STAFF RESPONSE TO PLANNING COMMISSION RECOMMENDATIONS

Figure 4-2 : Maximum Floor - to - Area - Ratio (FAR) by Right (with no Development Bonus)

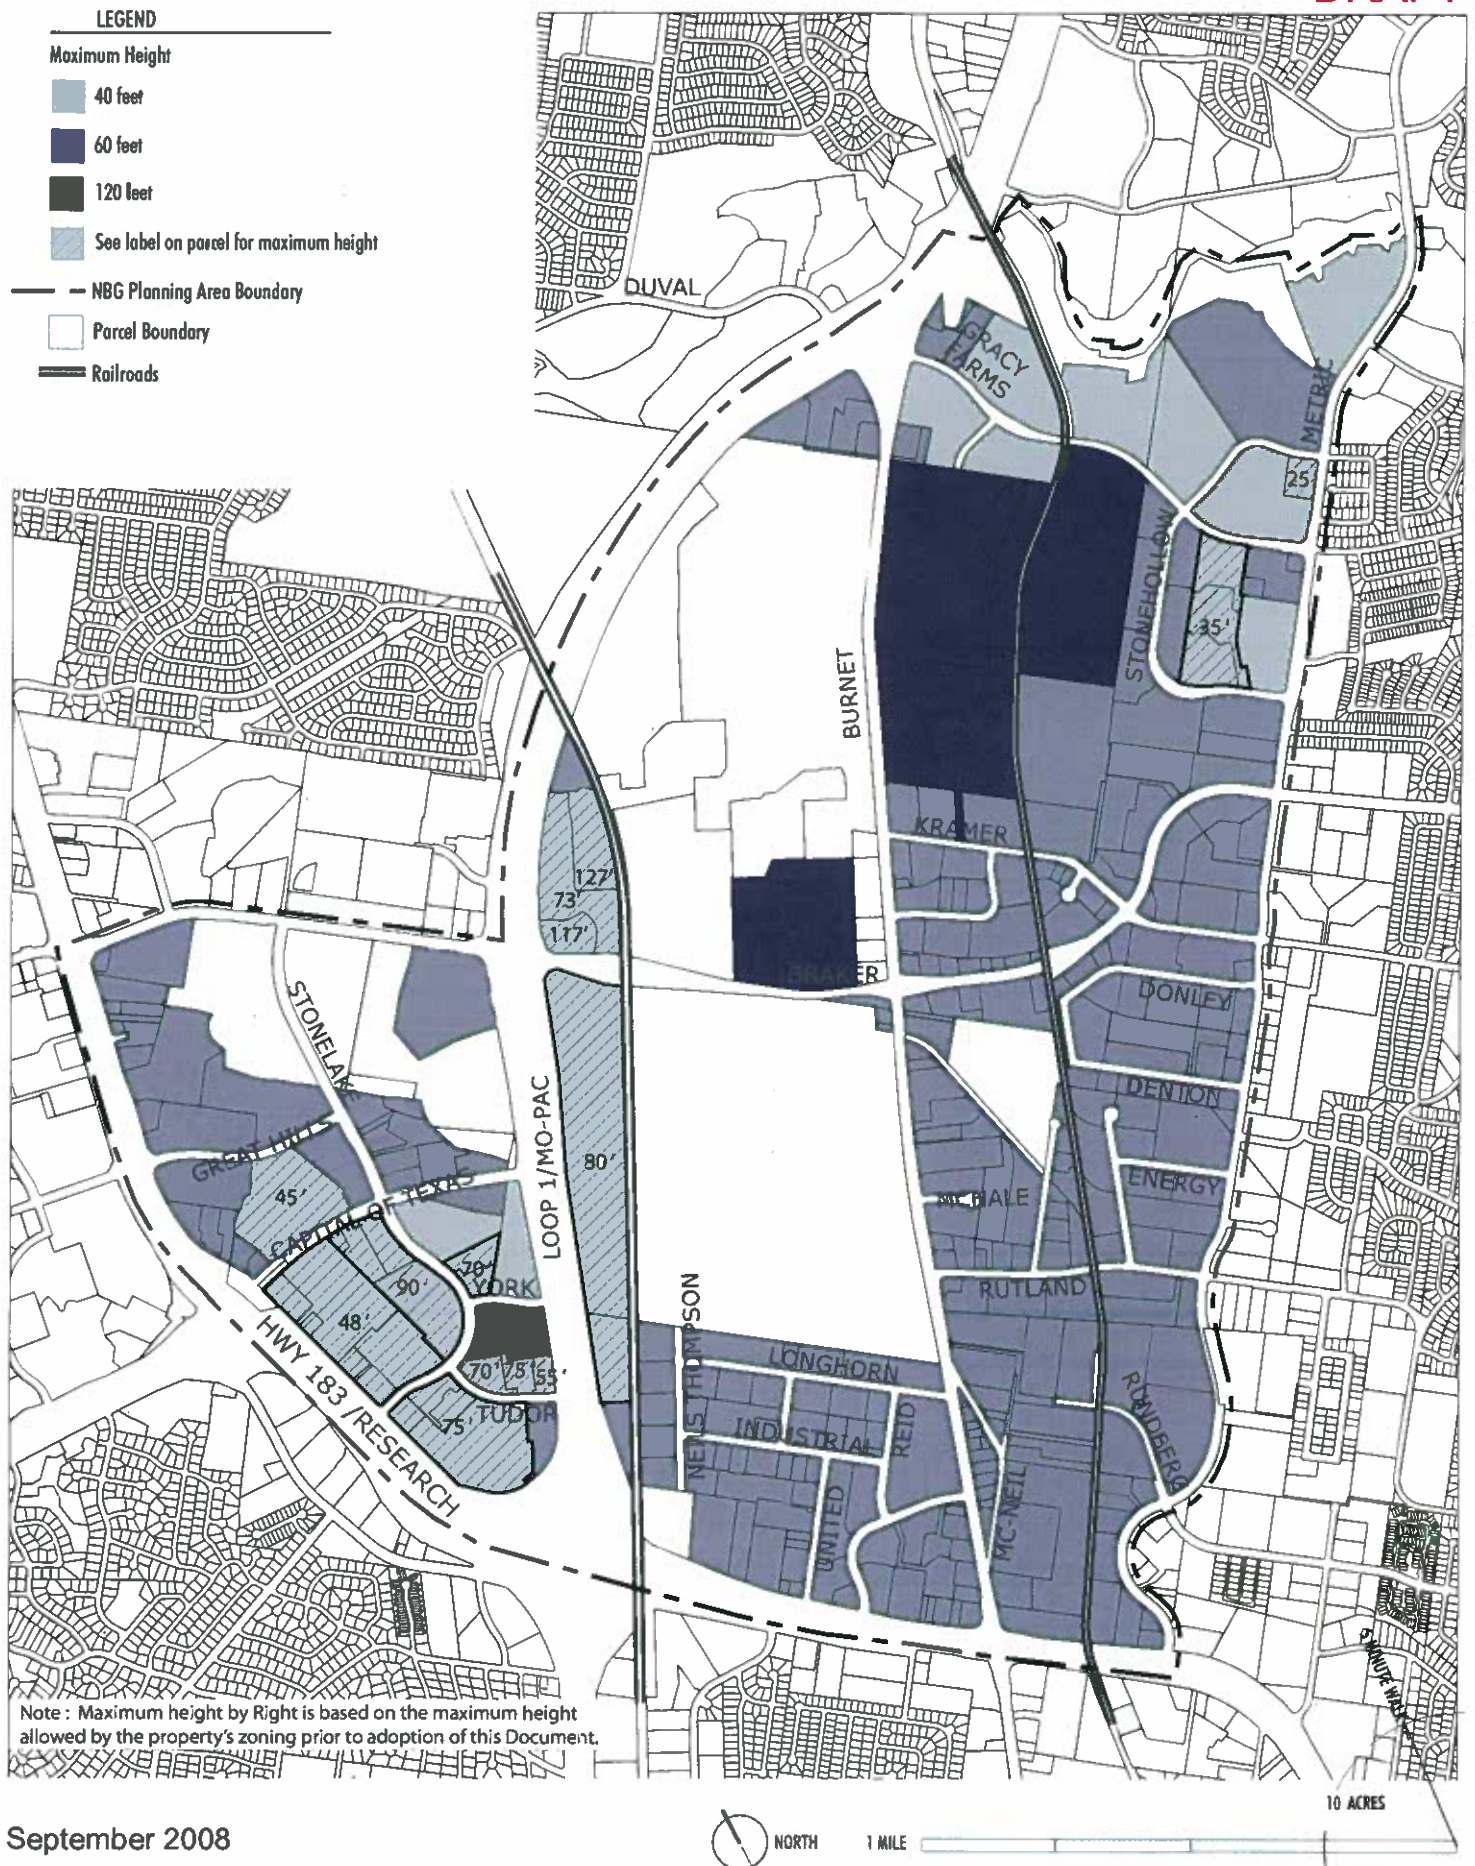
On the Braker Pointe tract (a portion of Tract 10) revise Figure 4-2 (Max. FAR by Right) and Figure 4-4 (Max. Height by Right) to reflect the base height and FAR allowed under the previous LI-PDA zoning prior to the 2006 Whole Foods zoning case (This change would allow 1.07: 1 FAR and 117 feet in height by Right).

On the Morse Family tract (a portion of Tract 7) revise Figure 4-2 (Max. FAR by Right) and Figure 4-6 (Max. Impervious Cover) to reflect the base FAR and impervious cover allowed under the previous CS zoning prior to the 2007 zoning change to MF-4. (This change would allow 2:1 FAR and 95% impervious cover).

Staff Recommendation: Staff concurs with this proposed change.

Recommendation Details: See attached Revised Figures 4-2 and 4-4.

Staff Recommendation: Staff concurs with this proposed change.

Recommendation Details: See attached Revised Figure 4-2 and 4-6.

PLANNING COMMISSION RECOMMENDATION
 OFF-STREET BIKEWAY OPTION
 STREET TYPE: PRIMARY COLLECTOR WITH PARALLEL PARKING (35 M.P.H or less)

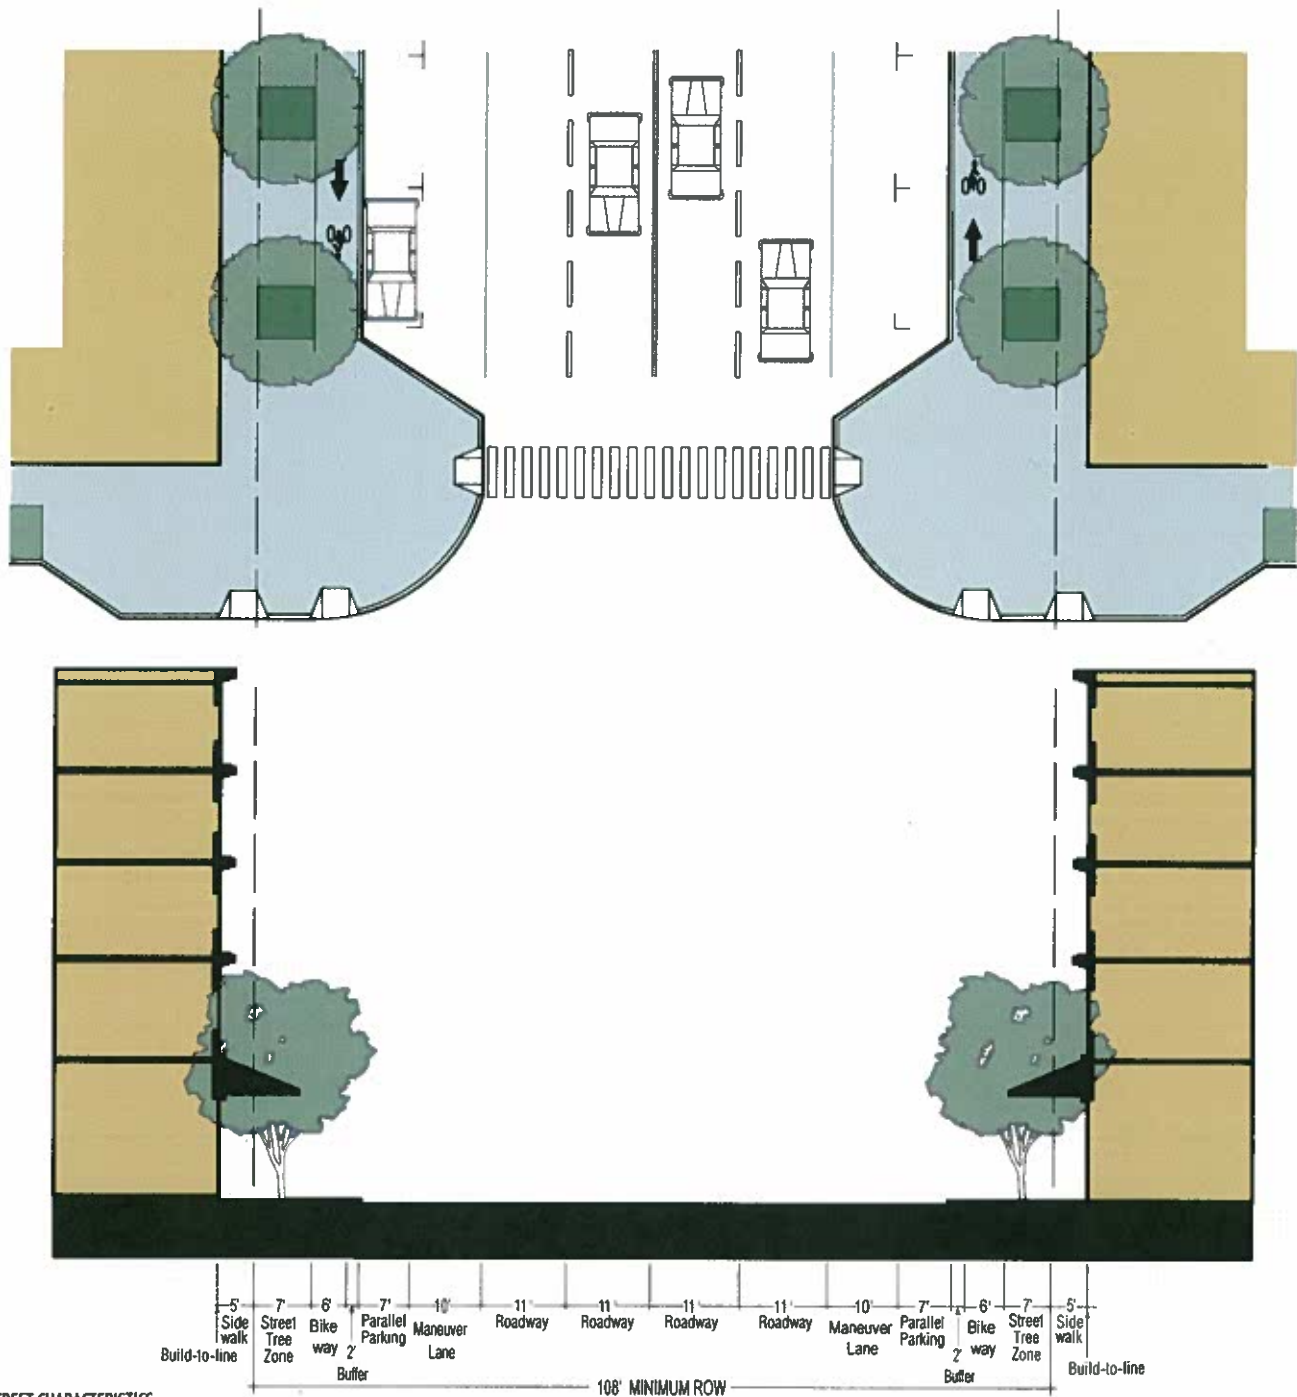
Amend Appendix A of the NBG Regulating Plan to include a new collector street cross-section that shows a separated off-street bicycle path.

Staff Recommendation: Staff concurs with this proposed change. Staff also recommends requiring the off-street bikeway cross-section for specific new collector streets designated on the NBG Collector Street Plan. This is to ensure consistent bike facilities from property to property as the new collector streets are built.

Recommendation Details: Appendix A would be revised to add two new Primary Collector - Off-Street Bikeway Option cross-sections (see attachment) and Section 3.5.2 would be revised as follows:

2. The collector street shown on Figure 3-12 running north-south located east of Burnet Road and west of the railroad tracks shall follow the Primary Collector Street (35 M.P.H or less) off-street bikeway option cross-section.
